HISTORIC AND DESIGN REVIEW COMMISSION

March 3, 2021

HDRC CASE NO: 2020-123
ADDRESS: 4674 S PRESA ST
LEGAL DESCRIPTION: NCB 7603 BLK 1 LOT S 124.2 FT OF 2 & SE 108.27 FT TRI OF 1
ZONING: C-2, RIO-5
CITY COUNCIL DIST.: 3
APPLICANT: David Ranjbar/Prime & Paradigm Construction, LLC.
OWNER: Shauaot Momin/SHAK & IKE CORPORATION
TYPE OF WORK: New construction
APPLICATION RECEIVED: January 25, 2021
60-DAY REVIEW: Not applicable due to City Council Emergency Orders
CASE MANAGER: Huy Pham
REQUEST:

The applicant is requesting a Certificate of Appropriateness for approval to construct 3,500 square-foot, one-story commercial structure at the lot on 4674 S Presa, on the west corner bounded by E Southcross to the north, S Presa to the west, and Stratford to the south.

SITE PLAN

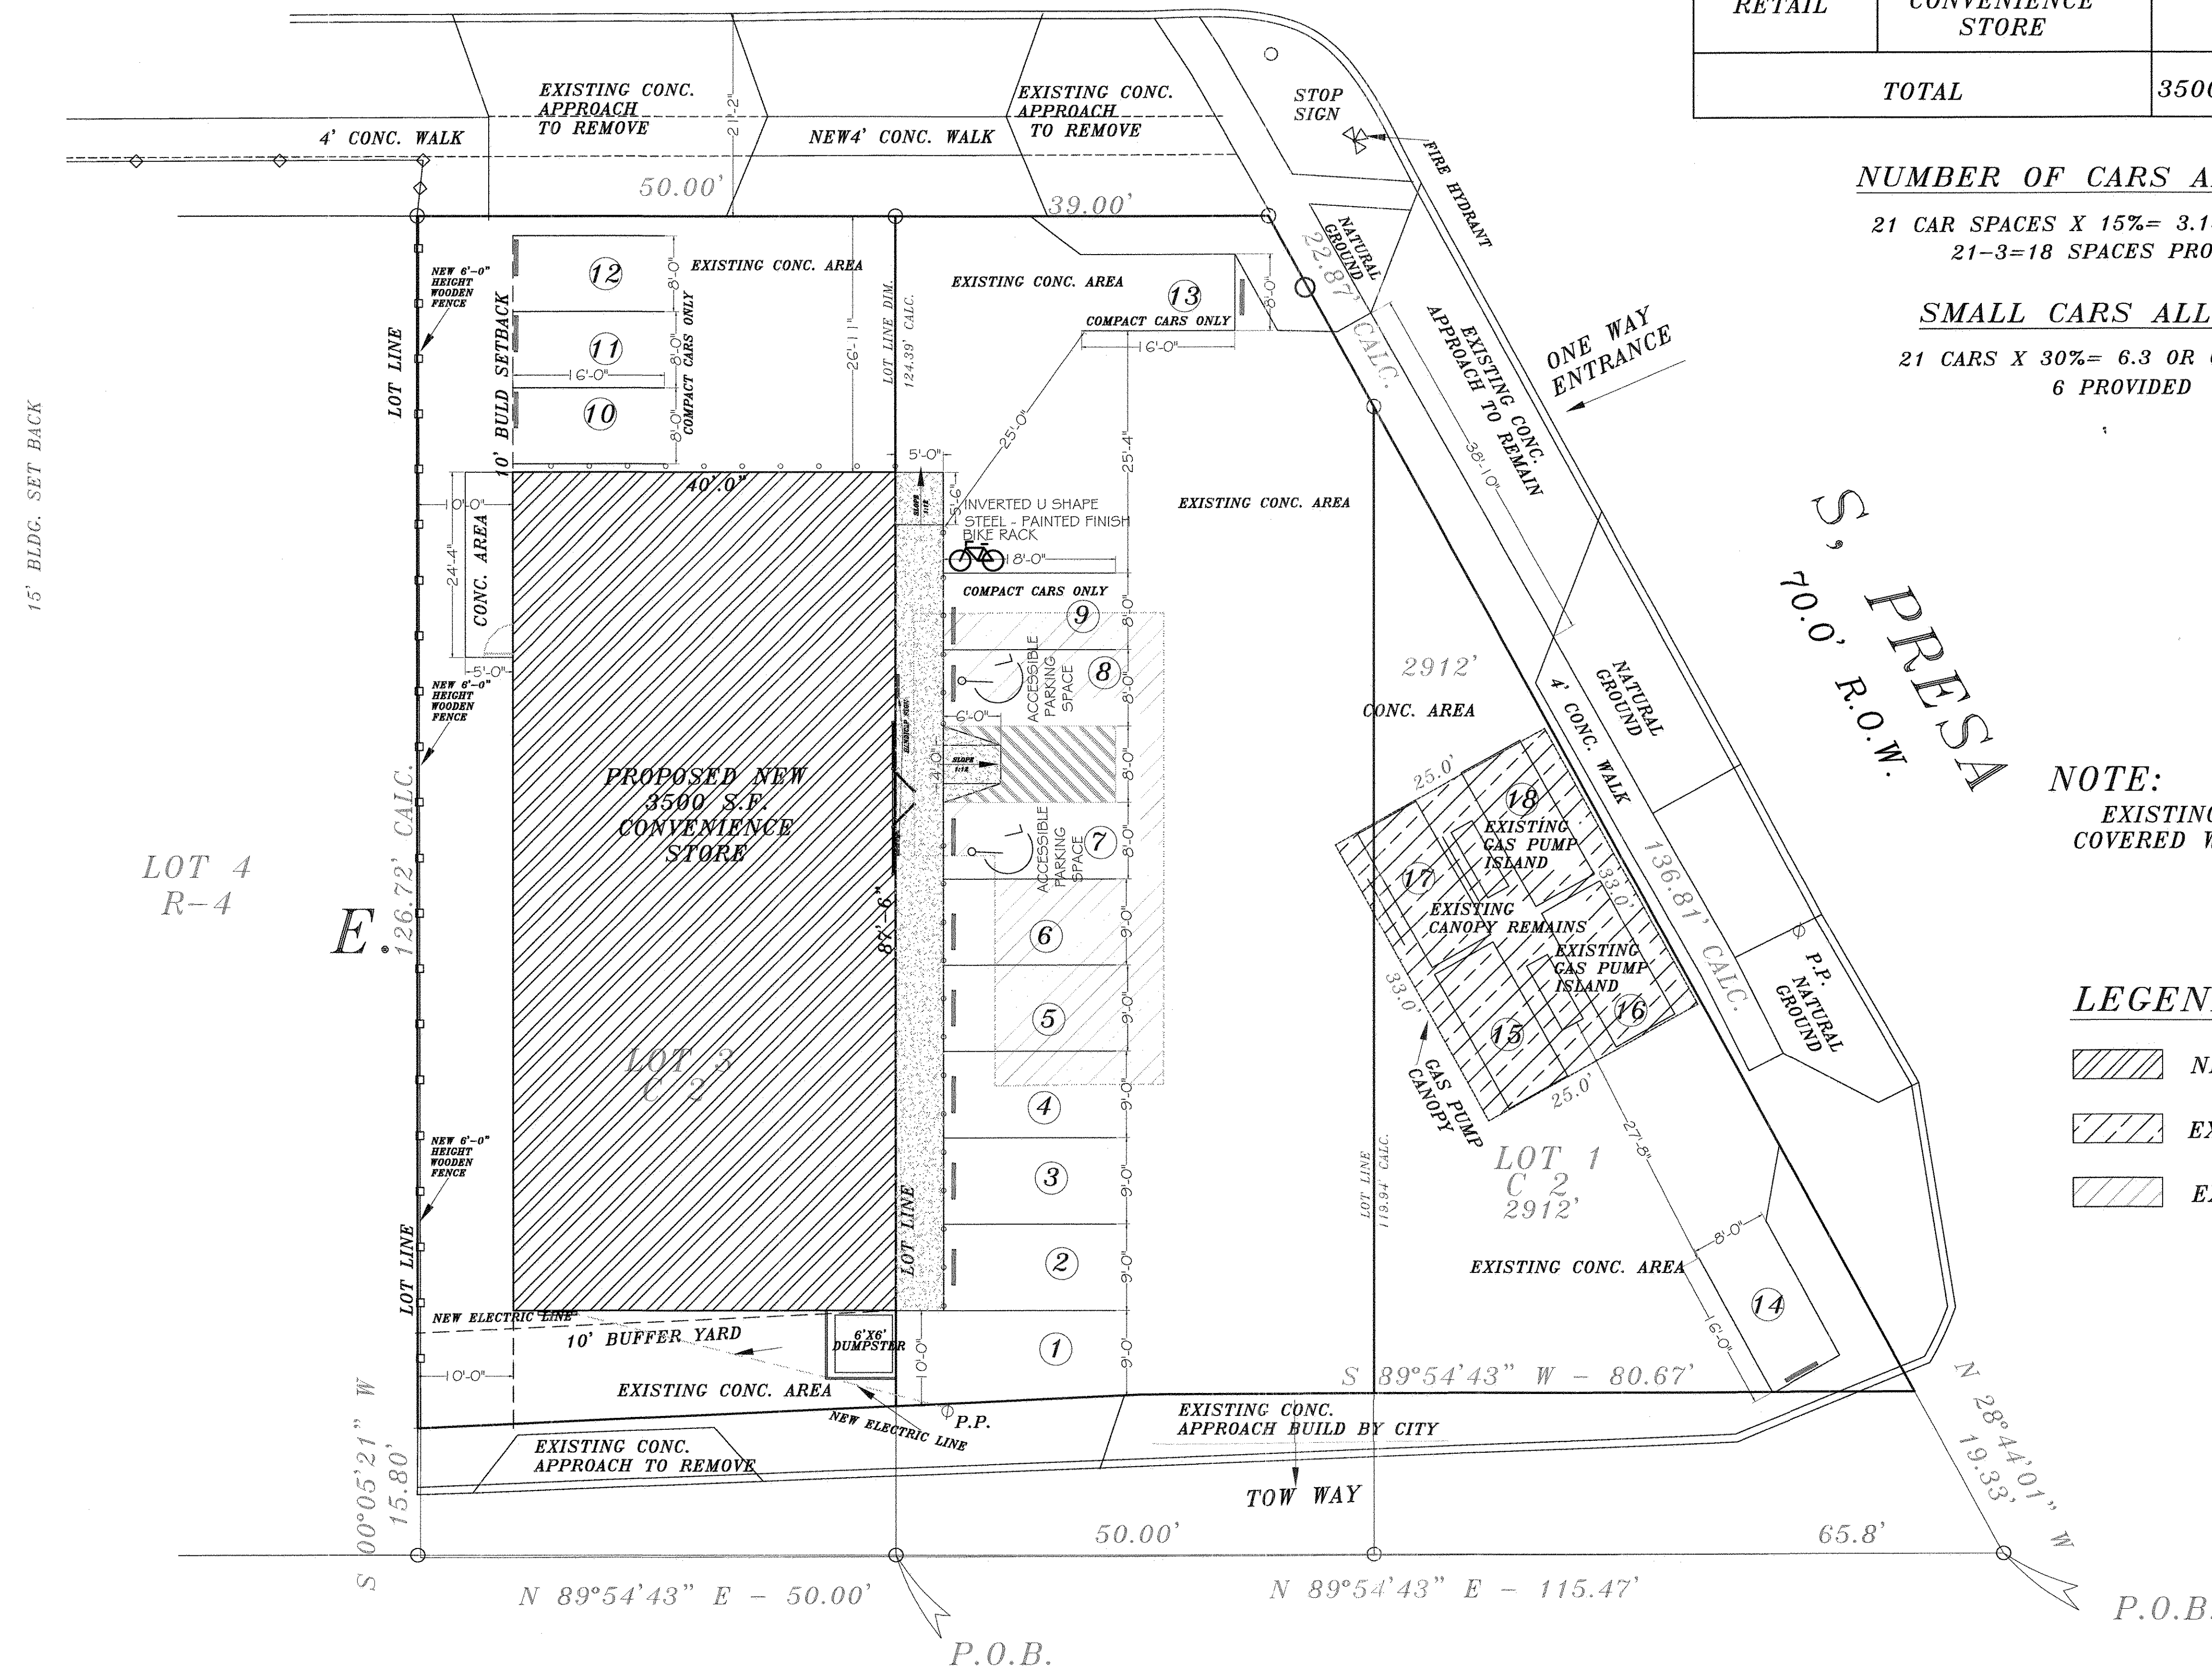
- e. PEDESTRIAN CIRCULATION – Per the UDC Section 35-672(a) in regards to pedestrian circulation, an applicant shall provide pedestrian access among properties to integrate neighborhoods. Per the applicant’s site plan, existing sidewalks will only be maintained along S Presa. Staff finds that sidewalks should be maintained around the perimeter of this corner property, on Stratford, S Presa, and E Southcross.

- h. **SITE DESIGN** – According to the UDC Section 35-673, buildings should be sited to help define active spaces for area users, provide pedestrian connections between sites, help animate the street scene and define street edges. Primary entrances should be oriented toward the street and shall be distinguishable by an architectural feature. The applicant has proposed a pedestrian entrance to front S Presa, consistent with the UDC.
